Mira / Extra Self Storage
Updated Review of A5 Mitigation

Re: Technical Note to Review A5 Mitigation prepared by DTA on behalf of ERSS dated 15.01.24

JOB TITLE		CLIENT	
Mira / Extra Room Self Storage		Mark Simpson	
DRAWING TITLE			
A5 – Drayton Lane – Woodford Lane Junctions Concept Mitigation Package 1			
SCALE	DRAWN BY	DATE	DRAWING No
1:1000@A3	BP	07/05/25	24316-04-GA
			REVISION

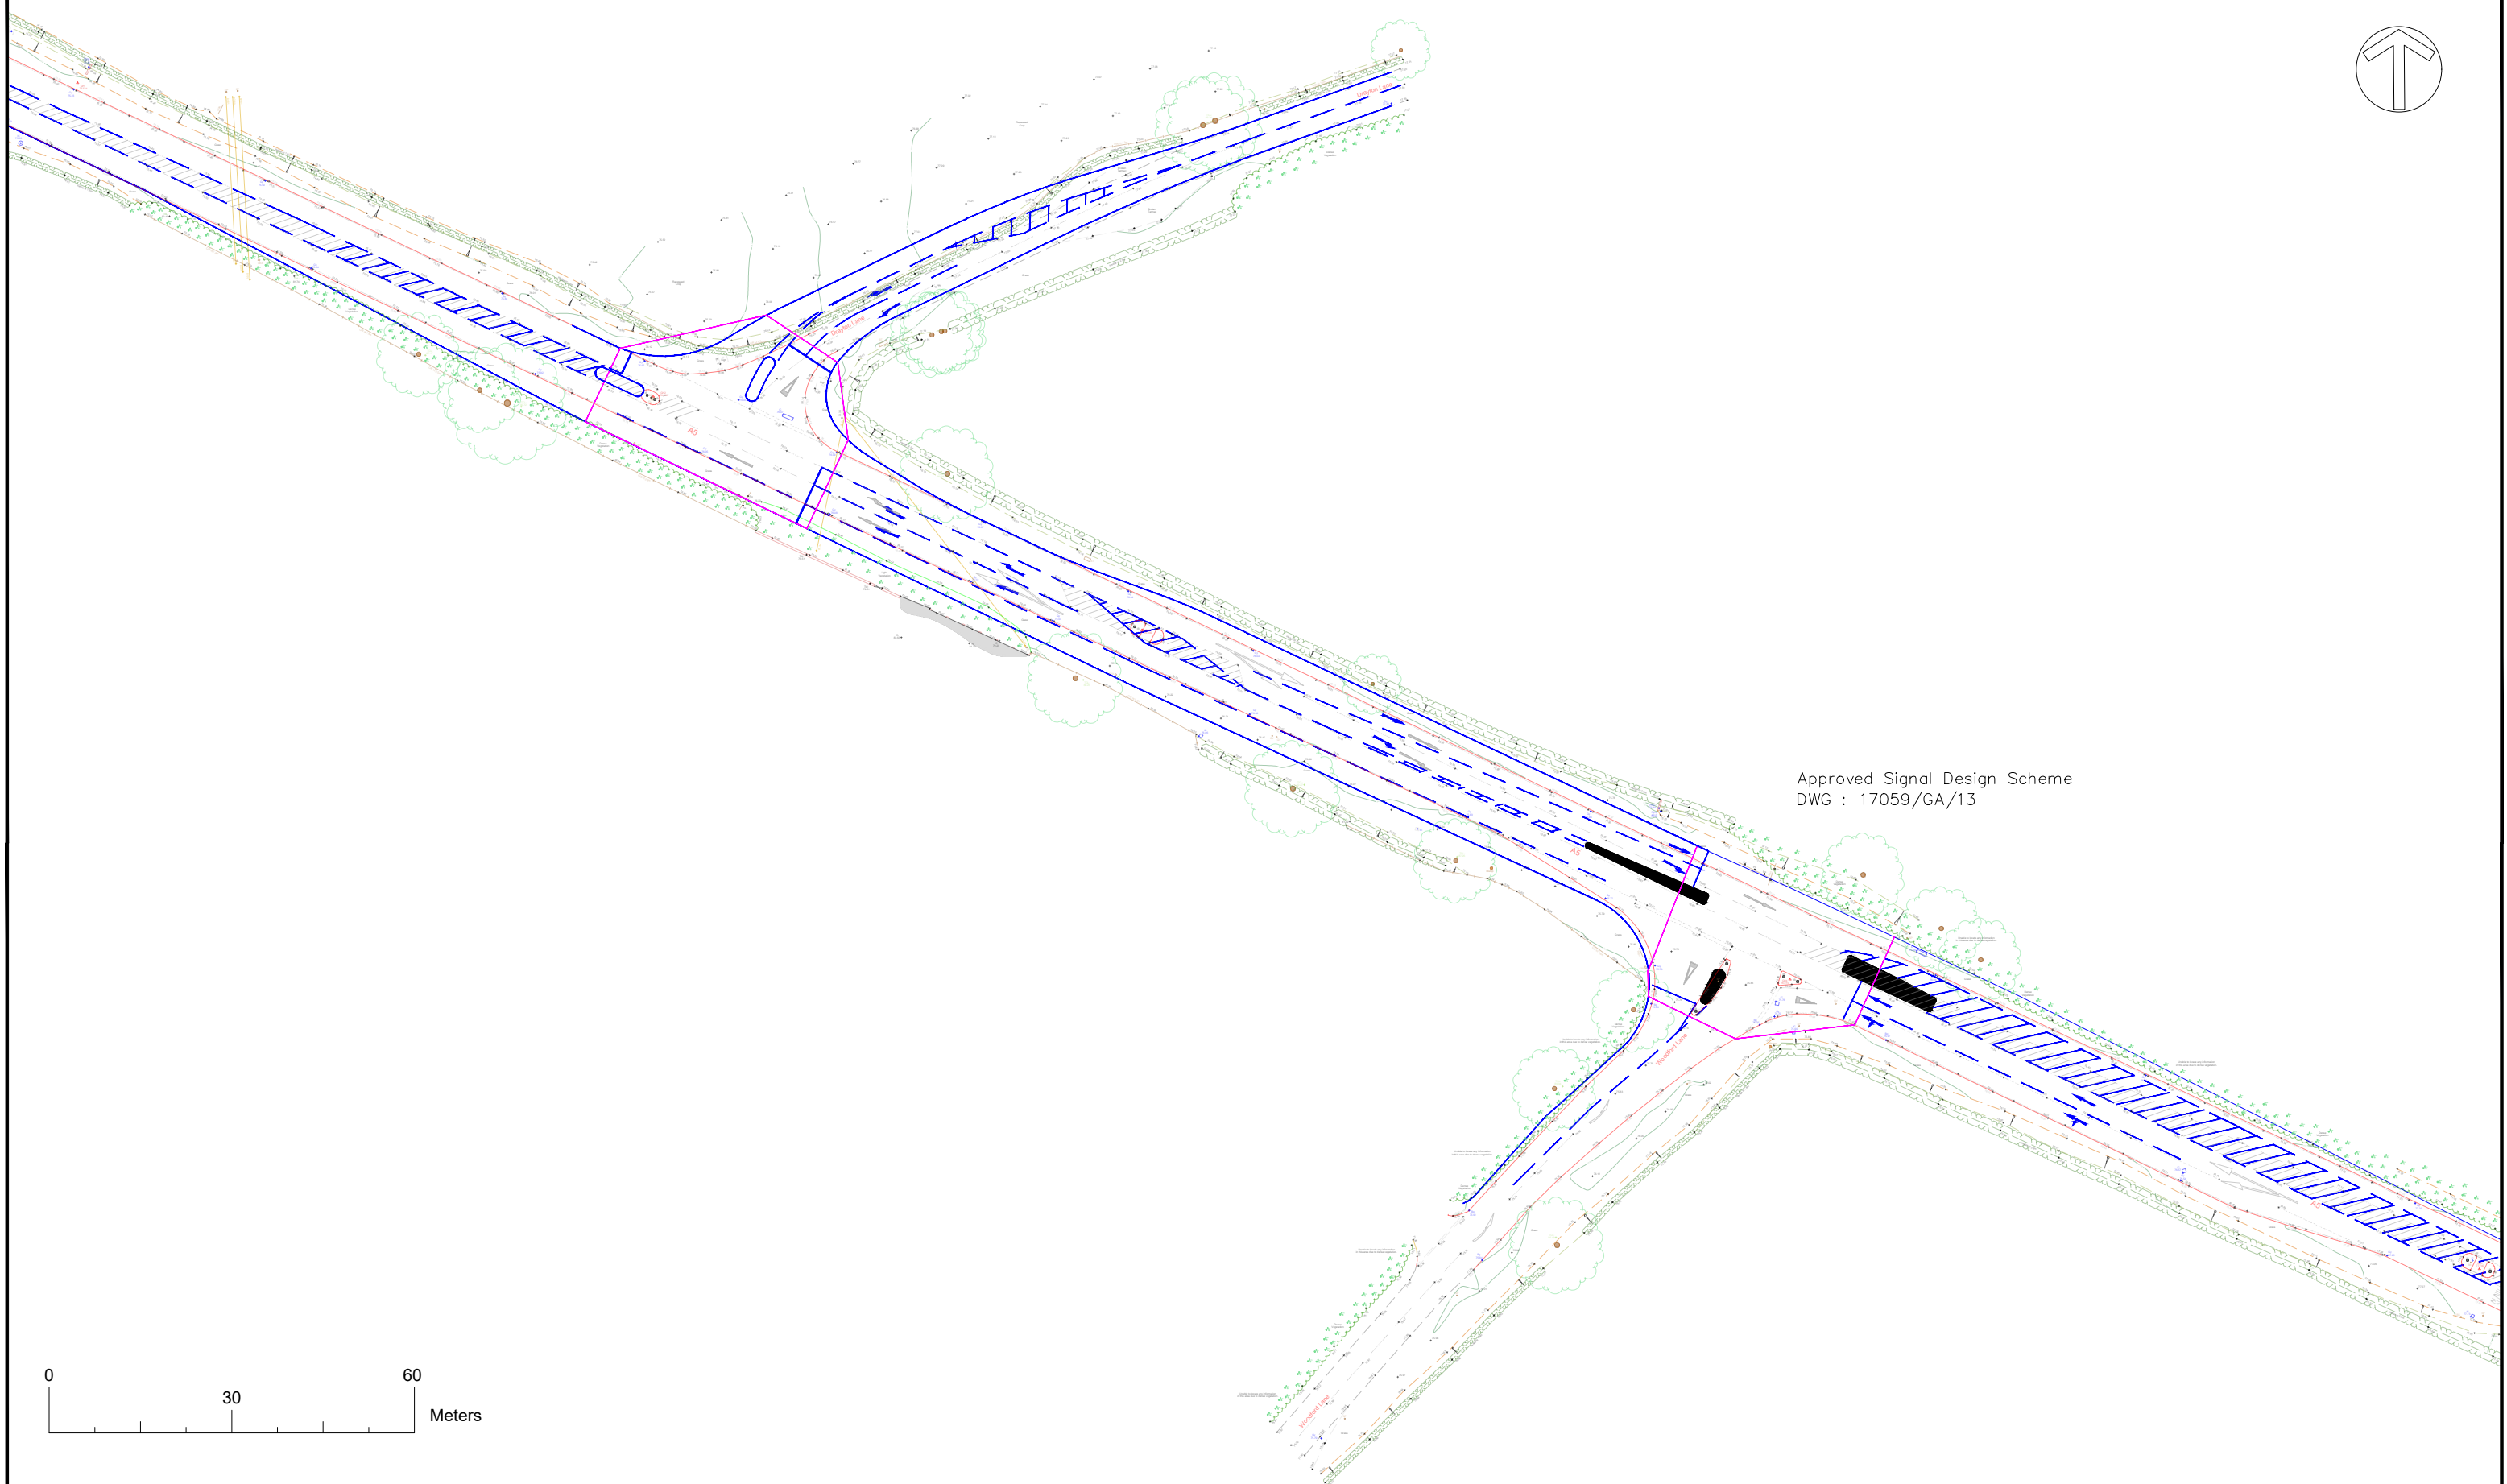
1. It is unclear why the degree of saturation and queuing on the A5 eastbound is highest in the AM1 scenario, despite the traffic flows increasing in the subsequent scenarios.
2. No swept-path analysis shown for HGVs accessing / egressing Drayton Lane.
3. No signal intervisibility shown.
4. No highway boundary shown.

- 4.1 To address GA comments the general arrangement drawing has been updated as shown at **Appendix B**. It is now based on a topographical survey commissioned by the client (provided separately at **Appendix D**).

- 4.2 Vehicle tracking has been undertaken based on a maximum legal articulated lorry (i.e. DMRB design vehicle) and these are provided at **Appendix E**. The layout has been adjusted to accommodate this vehicle.

- 4.3 The highway boundary extents are shown. In practice our client is willing to contribute land in the northwest quadrant of the Drayton Lane junction to support an appropriate layout and hence land is not considered to be a constraint.

- 4.4 Signal intervisibility envelopes are shown. Intervisibility is achievable at the Drayton Lane junction. Forward visibility to a primary signal head is achievable on all approaches. A nearside primary signal head can be provided on the Drayton Lane minor arm.
